Re: Rapiscan AIT System Radiation Survey Reporting

R-0646-1 Addendum (Documentation Errors)

| Product Name | Secure 1000SP (Single Pose) |
| Serial Number | S51009009 |

1. In Beam Dose Measurement: Survey Table. 1

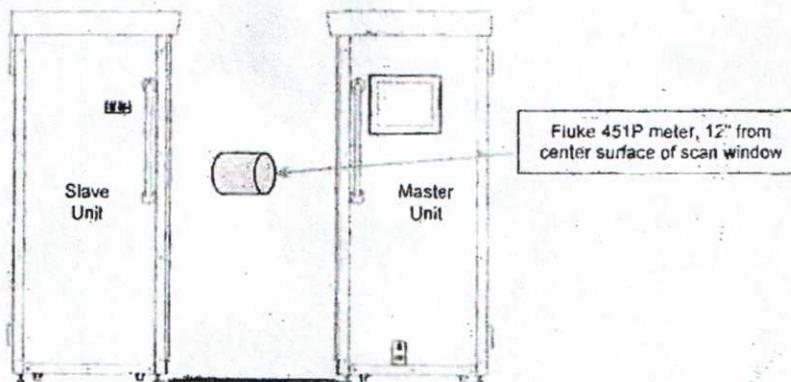
1. No value indicated for background radiation. Typical values range from 7uRem/hr to 13uRem/hr at sea level. Note: Absence of value has no adverse impact on calculations.
2. Technician indicated scan time as 7 seconds. Correct scan time is 3 seconds.
3. TABLE 1: Incorrect presentation of data in Column 3 for Measured Exposure. Indicated values are 31uR and 40uR. Corrected values are 3.1uR and 4.0uR. The values were corrected by technician when calculating Effective Dose.
4. TABLES 2 and 3: Incorrect presentation of data in Column 6 for Dose Equivalent. Indicated values are .18 uRem. The correct value should be 1.8 uRem.

The service technician should attend refresher training.

The corrected data indicates this system was operating within expected parameters. No re-survey is required for this system.
